Region NOR County IRON Report Date 1975 Classification LFF
Water Body: Vaughn Creek
Discharger: Saxon STP

From: Stubbe, Pamela J
Sent: Tuesday, October 22, 2002 11:33 AM
To: Watson, Susan S; Bub, Laura A
Cc: Jaeger, William C; Koshere, Frank J
Subject: Saxon S.D. - Vaughn Creek Stream Class

SUBJECT: Saxon Sanitary District WQBEL's

Wastewater Receiving Stream Classification

Dug ditch channel of the
upper reaches of Vaughn Creek at
road crossing between Sections 1 & 2, T. 46 N., R. 1 W.

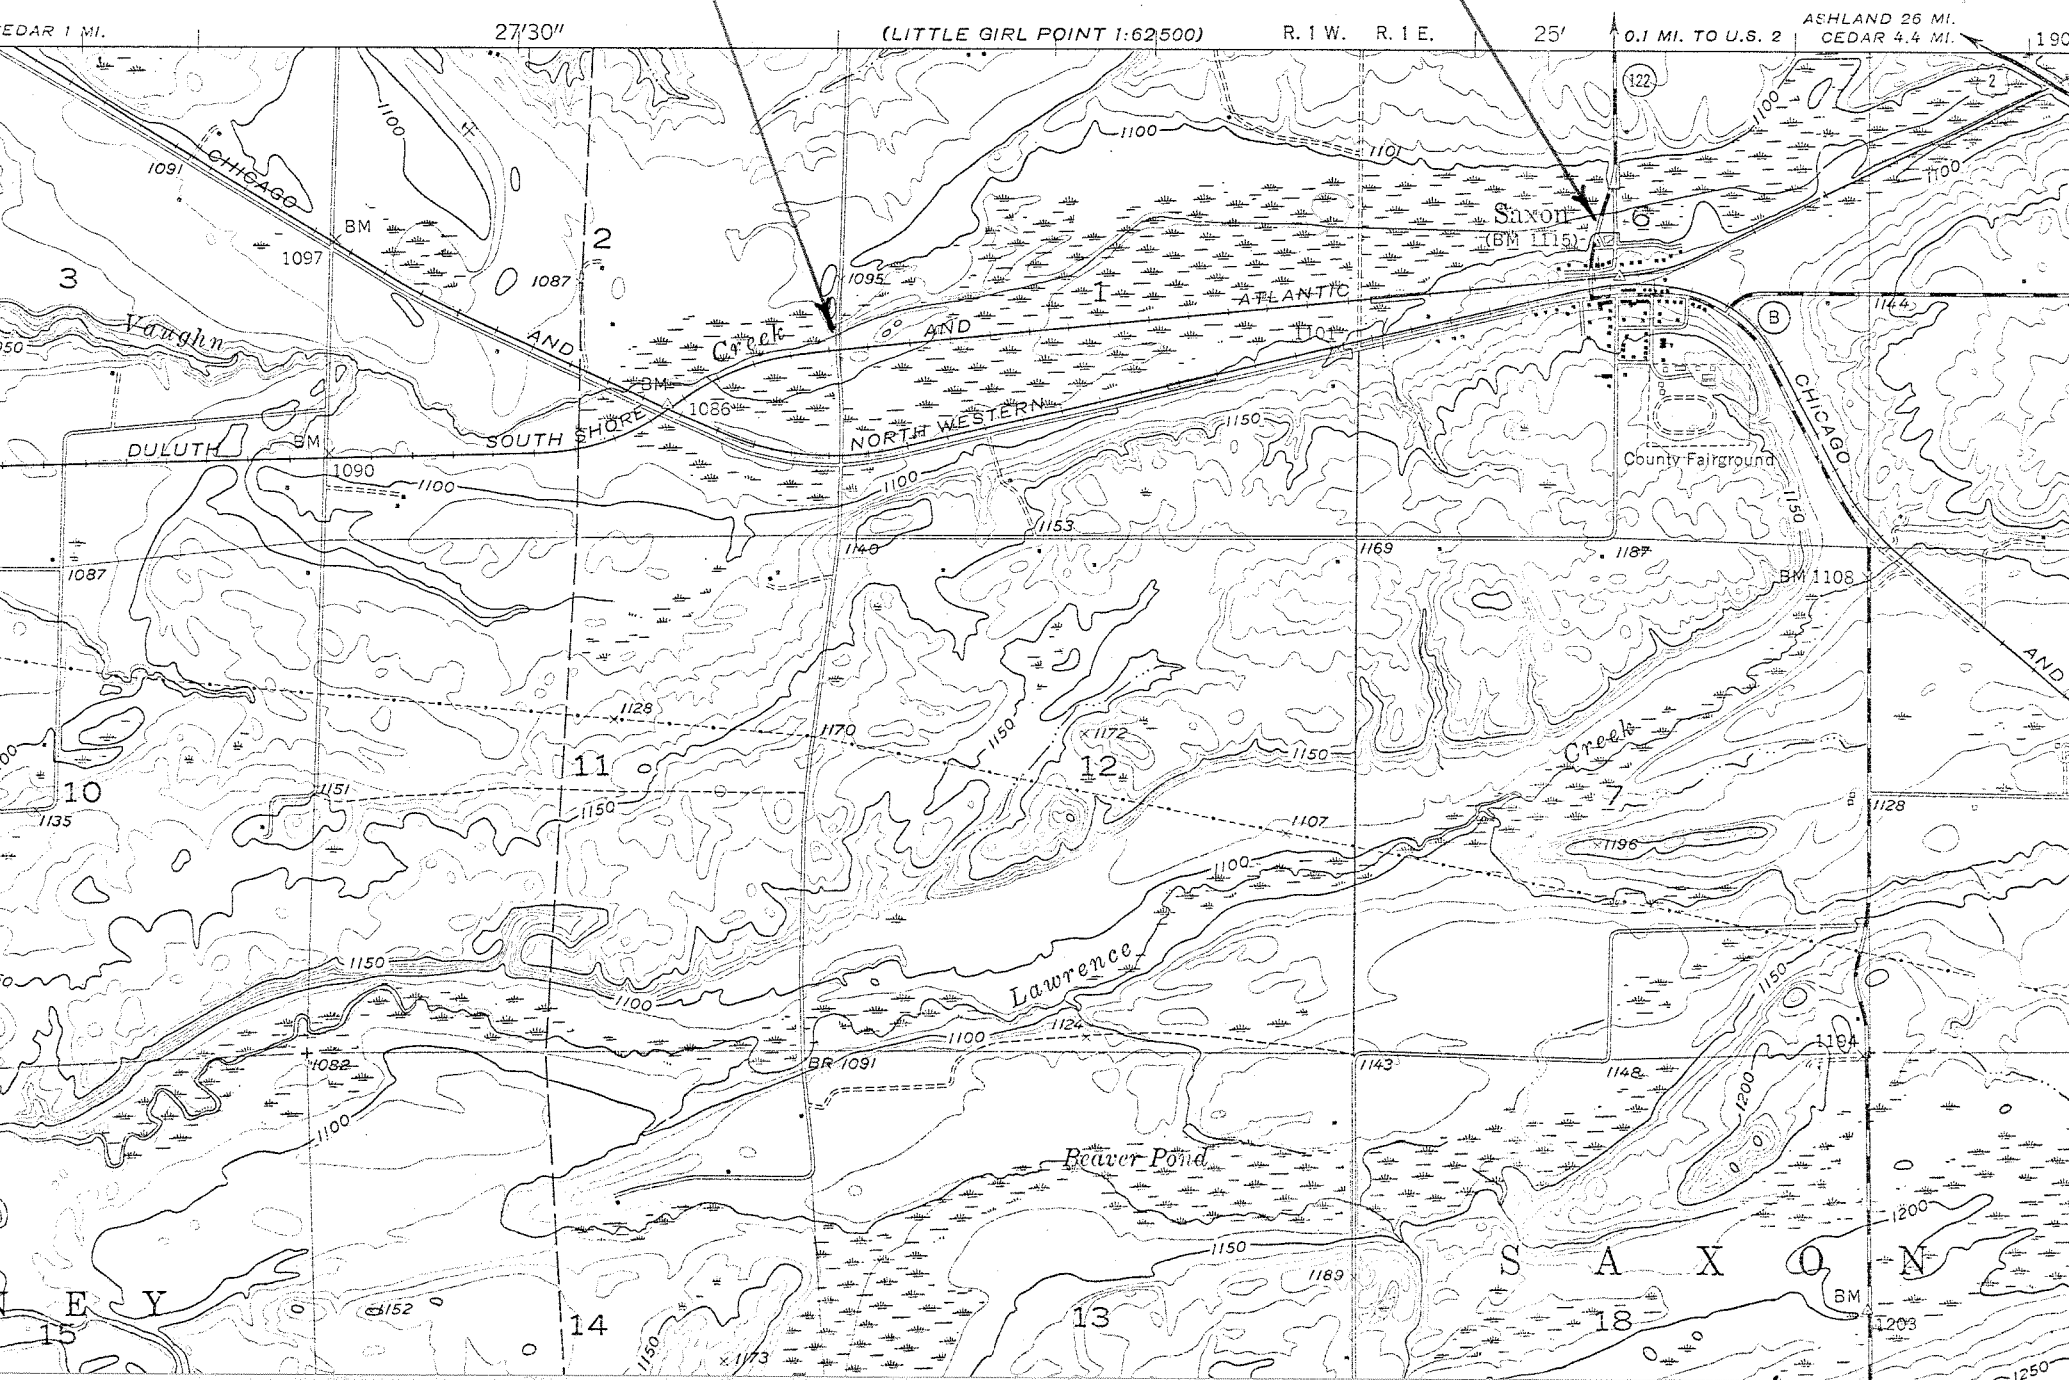
Vaughn Creek is considered a Class II trout stream for its entire length in Iron County. A fish management investigation in 1965 showed the presence of native brook and rainbow trout although no shocking operations were conducted above the road crossing between Sections 2 and 3. A field investigation on September 4, 1975 revealed that the upper section of Vaughn Creek is characterized by intermittent flow. The attached picture shows the channel crossing between Sections 1 and 2 to be dry on that date.

The dug ditch representing the headwaters of Vaughn Creek in Section 6, T46N, R1E, and Section 1, T46N, R1W, shall be classified as a "non-continuous stream" with a subcategory of "intermediate aquatic life".
